Our Ref: ABP-303726-19

Re: A mixed-use development which includes a six-storey hotel, six-storey car park, five-storey residential building, three five-storey office buildings, two-storey cultural/performance centre, two-storey mixed-use restaurant/café/specialist retail building, new sea wall around the existing Trinity Wharf site, 64 berth floating marina and all other site infrastructure works and ancillary works.
Trinity Wharf, Trinity Street, Wexford.

PROPOSED DEVELOPMENT AT TRINITY WHARF, TRINITY STREET, WEXFORD
Ref PL303726 - OBSERVATION/COMMENT TO AN BORD PLEANÁLA (ABP)

Figure 1 - Illustration of Impact upon McMahon Building Supplies

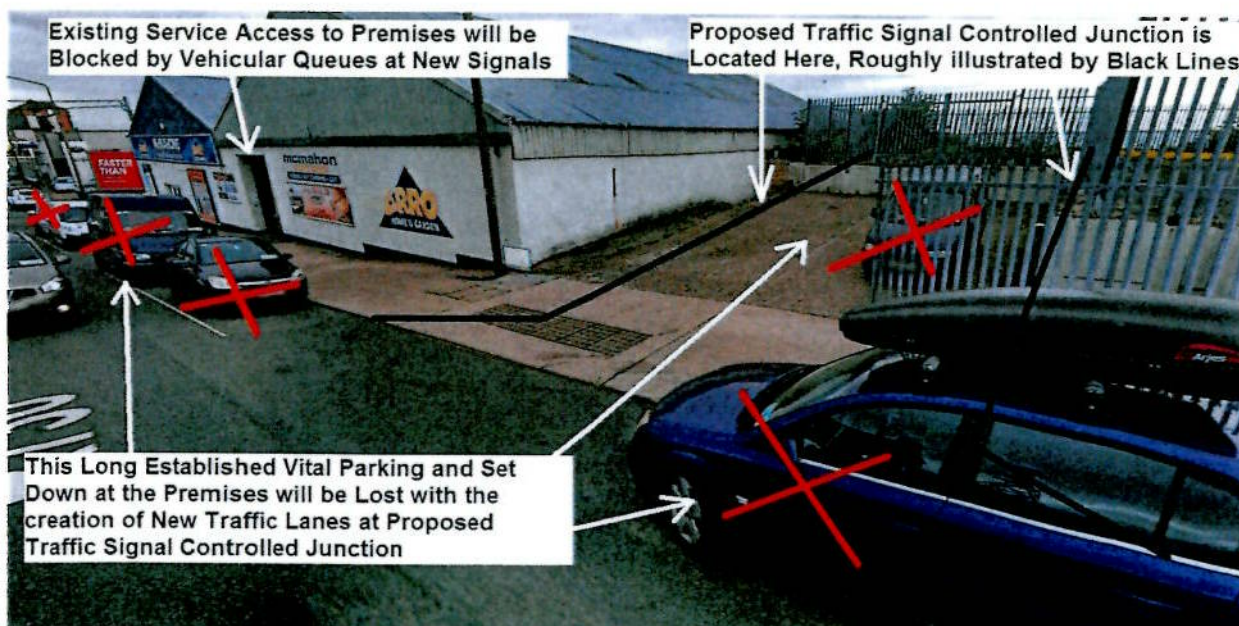
It is important to note that our client supports the proposed development BUT the current proposed access arrangement will, in my opinion, have disastrous implications for his long established successful town centre business, in terms of premises access for stocking/supplies and deliveries, and in terms of availability and convenience of customer parking. An alternative and safe access, given the frontage, is likely available to the applicant.

It should also be noted that the creation of a traffic signal junction at our clients premises at the service and collection entrance to his timber storage (Refer Figure 1) will in future require customers and large vehicle deliveries to cross 2 lanes of traffic immediately at a traffic signal junction, when traffic queues at the proposed stop-line will often physically prevent this occurring. This appears to have been totally ignored by the Applicants Design Team and indeed by the Road Safety Auditor.

Figure 4 - Applicants Junction Design AND Associated LiNSiG Capacity Model (All Extracted Directly from the ROD TA Report)

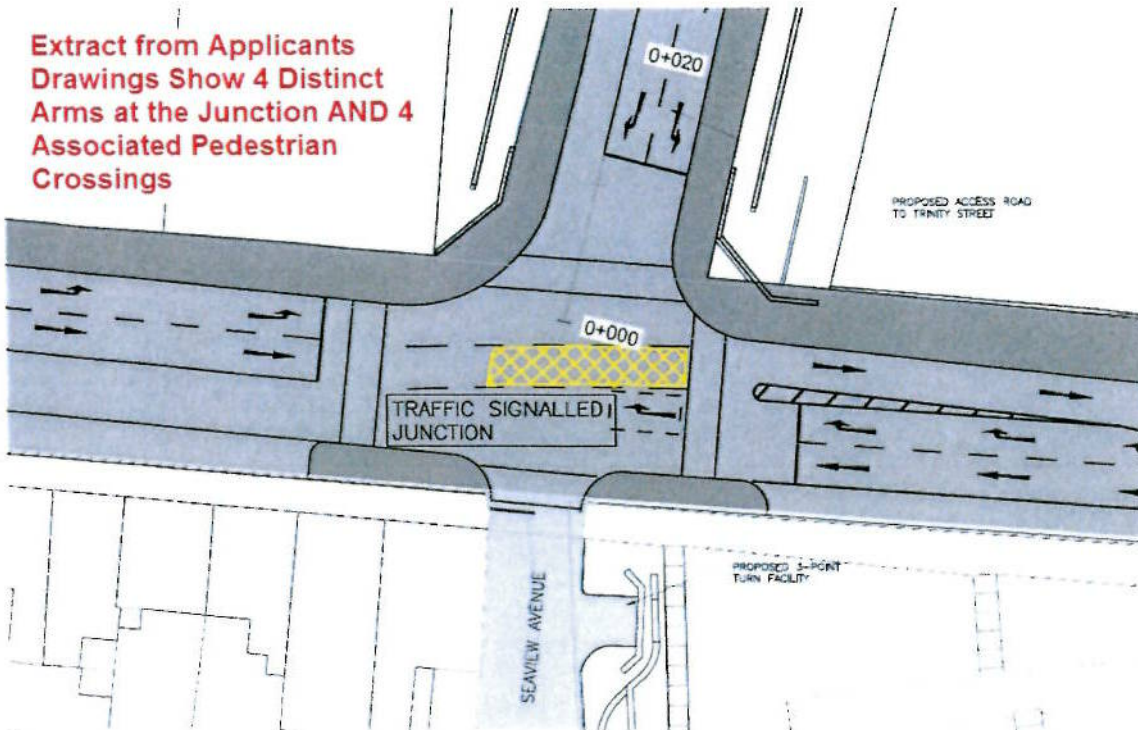
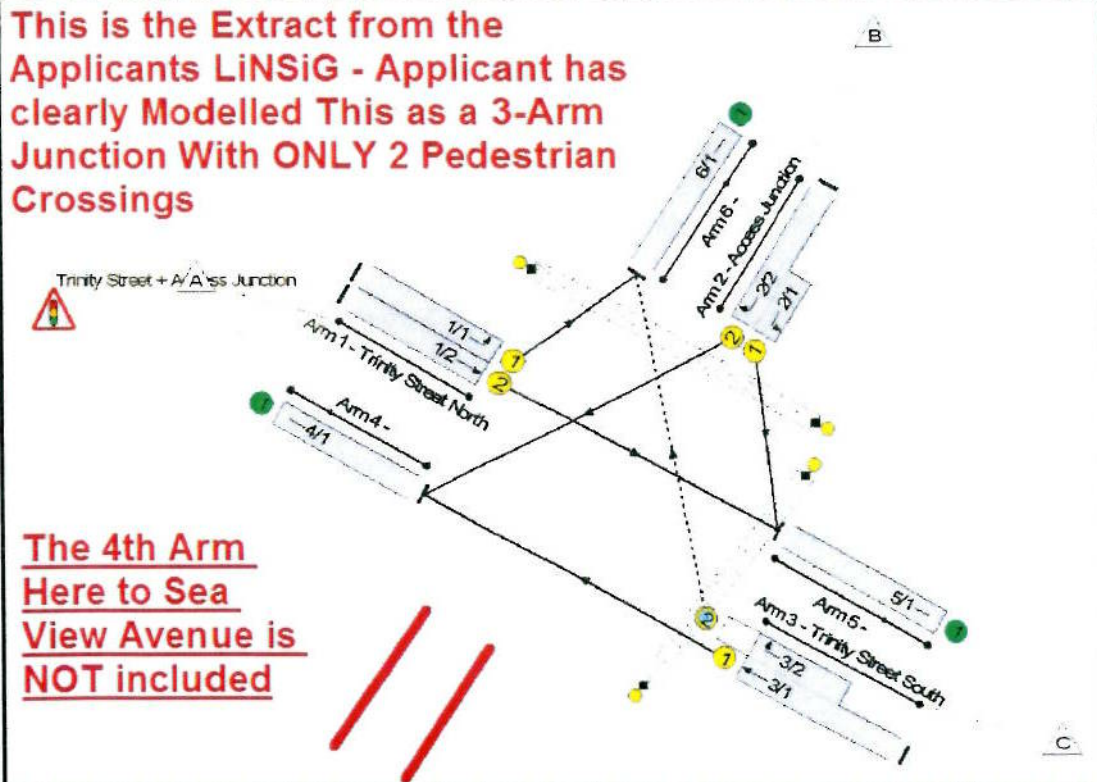
Extract from Applicants Drawings Show 4 Distinct Arms at the Junction AND 4 Associated Pedestrian Crossings

This is the Extract from the Applicants LiNSiG - Applicant has clearly Modelled This as a 3-Arm Junction With ONLY 2 Pedestrian Crossings

My basic point illustrated, as simply as possible in **Figure 4** above, is that the LiNSiG Modelling undertaken clearly does not reflect the applicant-proposed junction design.

The correct introduction of the 4th Arm into the capacity model, and the correct introduction of an all-red pedestrian phase, both of which are clearly illustrated in the Applicants Design, along with remedying other technical problems with the model which are difficult to explain in a coherent way (for example "cycle time", "inter-greens" and "stage minimums"), will have significant implications for Traffic Capacity and Modelled Traffic Queues and may have significant knock-on effects on traffic safety considerations.

Figure 5 - ROD Stage Diagram (Clearly Shows No Ped Crossing of Trinity Street N or of Seaview Ave AND No Stage for Vehicles leaving Seaview Avenue)

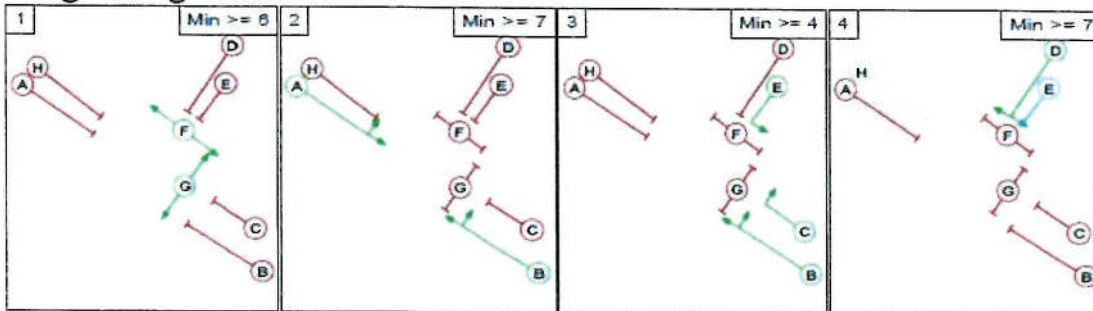
This is further confirmed through a review of the Junction LiNSiG "Stage" Diagram submitted which clearly shows **NO PEDESTRIAN CROSSING OF 2 ARMS** and **NO SIGNAL STAGE FOR SEAVIEW AVENUE** (As evidence Refer extract directly from the ROD Model Stage Diagram as **Figure 5** below)

Figure 6 - Noisy Traffic Signal Equipment Not Shown

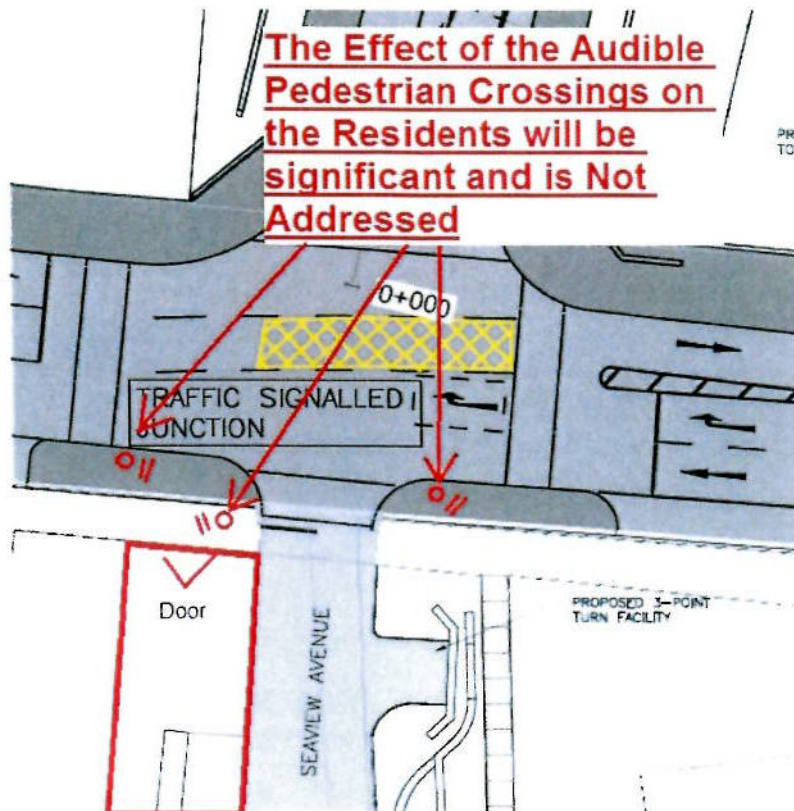
As an example - We note that the introduction of an Audible Mobility/Visibility Impaired on Call Pedestrian Crossing immediately beside long established private residential family homes (at their front door) will have significant nuisance and disturbance consequences for the residents - and this does not appear to have been addressed (illustrated in **Figure 6** below).

Notwithstanding the Noise Issue, people would be standing/queuing waiting to cross immediately outside the residents front door.

Figure 8 - Traffic Signal Junction Inter-Visibility

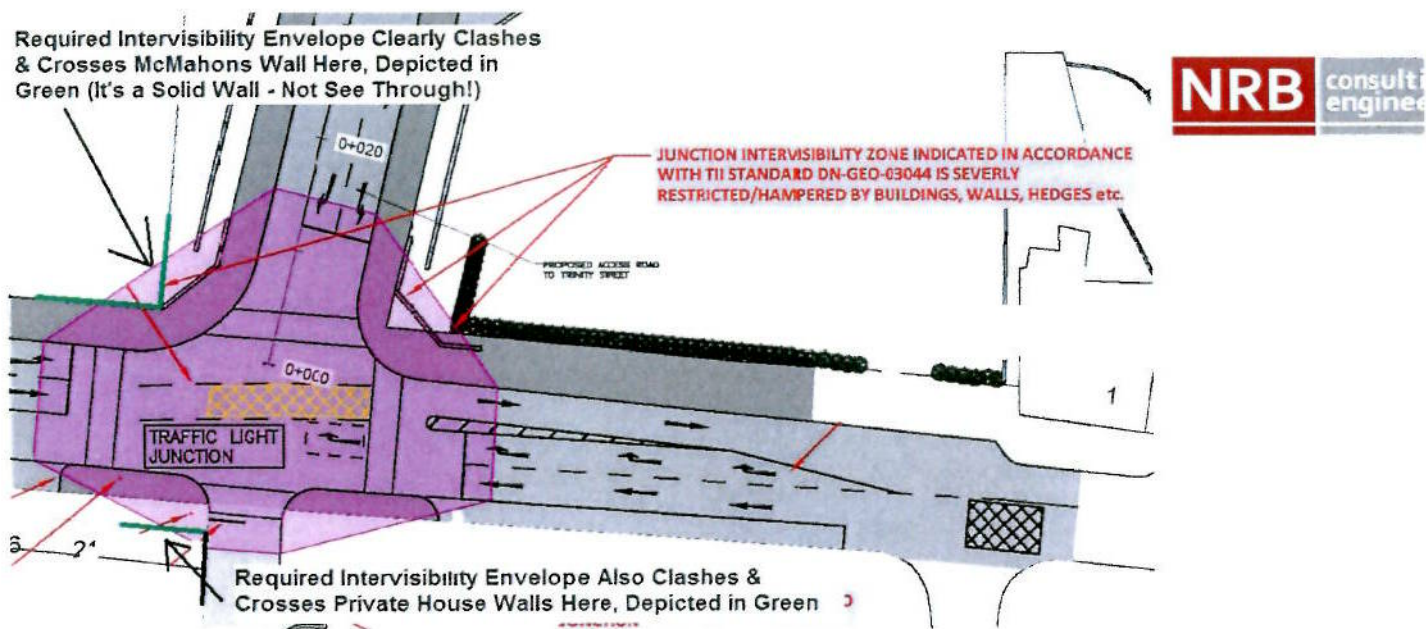
- We enclose the Signals Inter-visibility design Guidance Extract from the Applicable TII DMRB Roads Design Guideline as **Appendix C** - Signal Inter-visibility is a key and fundamental safety/design requirement for signal junctions that can very often overlooked by signal junction Designers at Planning Stage. In the particular circumstances of Seaview Avenue, with a private house boundary wall abutting the mouth of the junction, it is in our view demonstrably **not** possible to meet the Statutory Guidance inter-visibility requirements. The Intervisibility Envelope also Clearly Runs through the walls of our clients premises (McMahons) on the opposite side of Trinity Street. This means that a safe standard traffic signal controlled junction **cannot** be delivered here without very significant design alteration **AND** Knock-on implications in terms of its location and design. This issue is depicted for ease of reference in the extract from our drawing included below as **Figure 8**,

Road Safety Audit Feedback Form

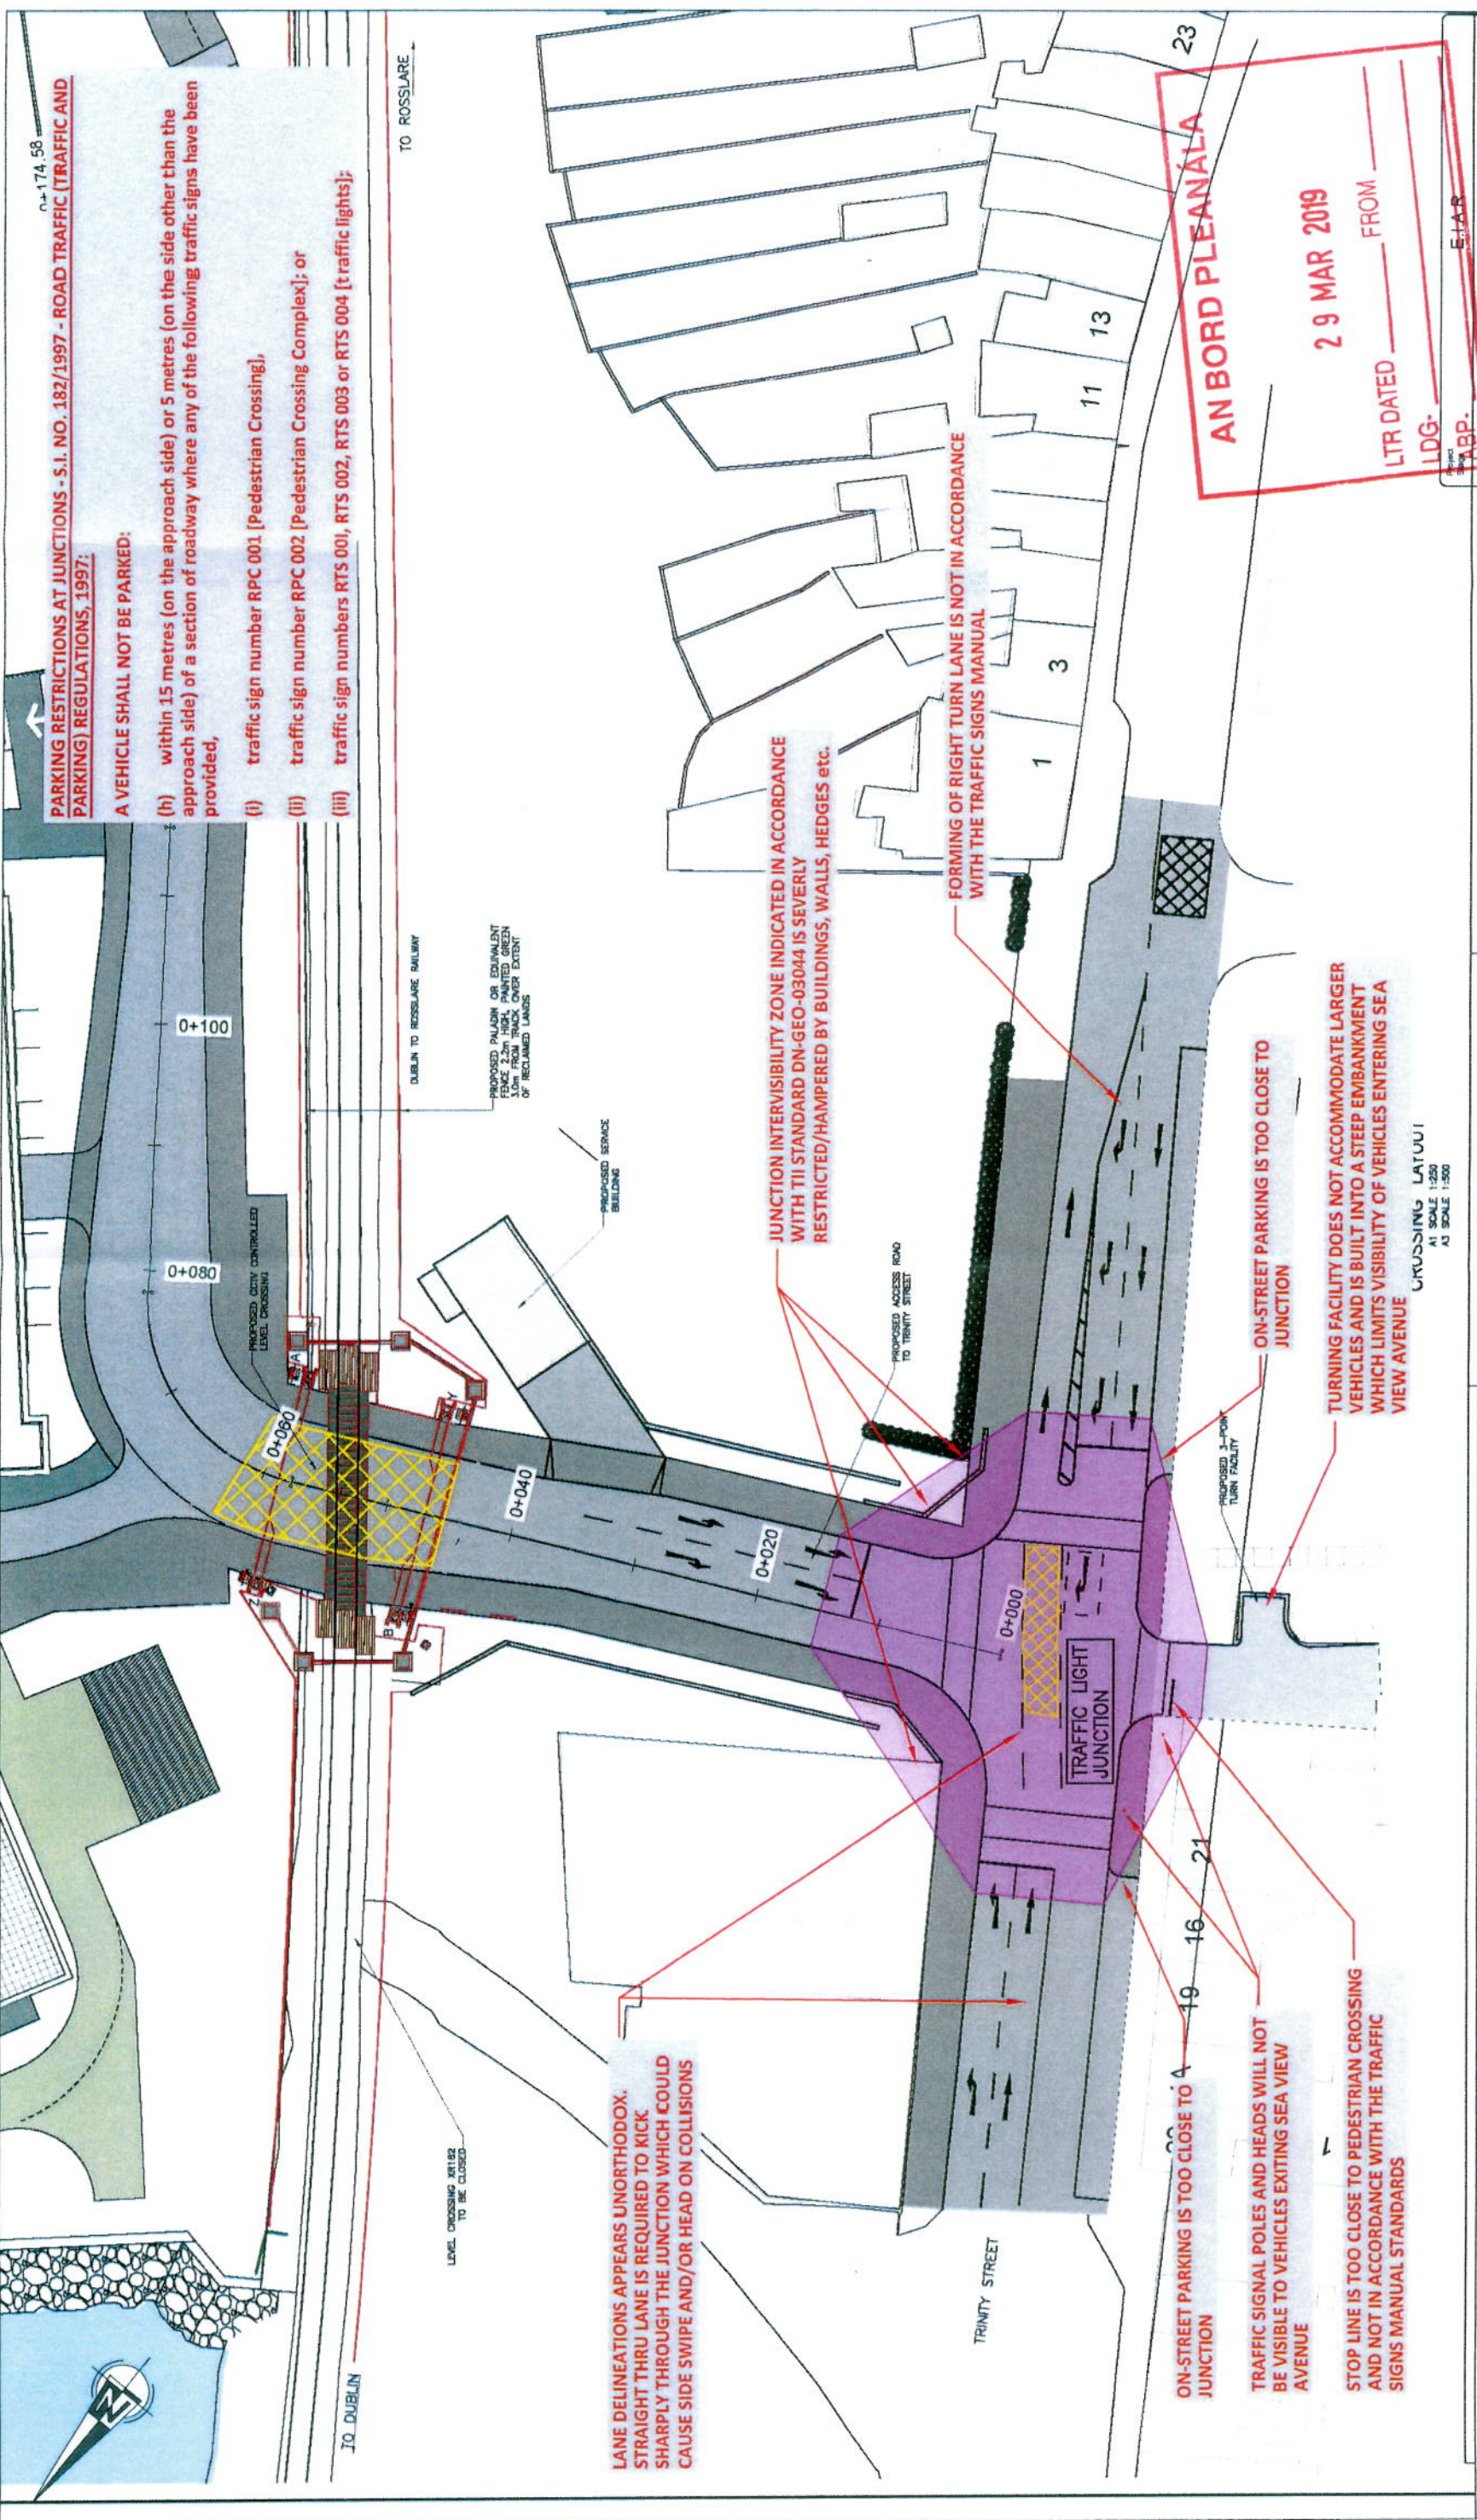
- The Submitted Feedback Form appears Unsigned by Both The Auditor AND Designer (Copy of same extracted from the ROD Report enclosed as **Appendix A**),
- The Myriad of Safety Problems with the Proposed Junction are correctly, clearly and unequivocally identified by the Auditor on a Drawing which the Auditor enclosed with the independent Audit (copy reproduced herein for convenience within **Appendix A**). We have also identified other safety issues and departures from Design Standards which the Auditor appears to have overlooked, and
- There appears to have been no attempt whatsoever to address these significant safety issues by the Applicant Design Team through a revised access design. These are issues which have significant implications for public safety and in our experience they cannot simply be dismissed as "Detailed Design issues", as they are of such a fundamental nature.

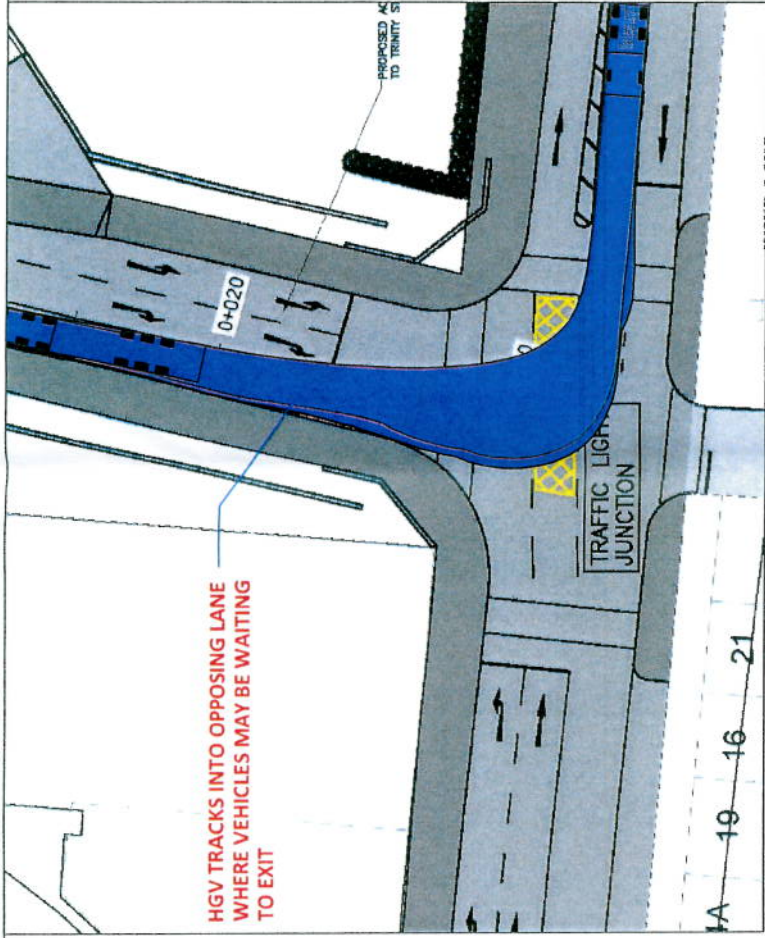
IT APPEARS THAT A HGV CANNOT MAKE THE LEFT IN TURN TO THE PROPOSED DEVELOPMENT

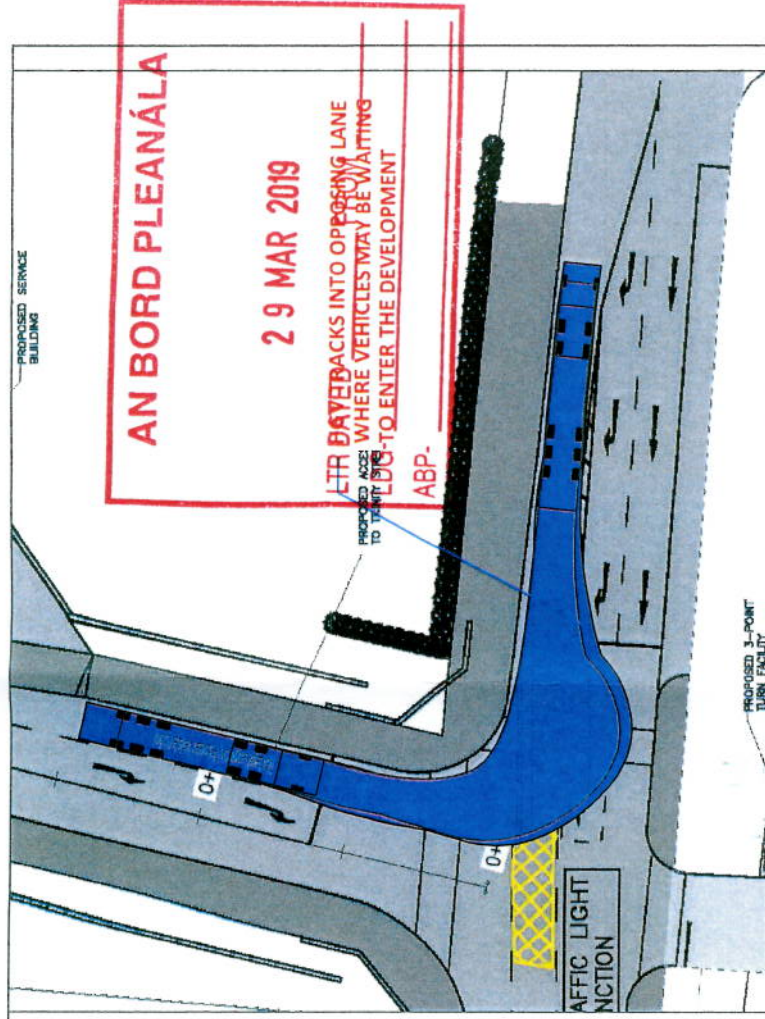
IT APPEARS THAT A HGV CANNOT MAKE THE RIGHT IN TURN TO THE PROPOSED DEVELOPMENT
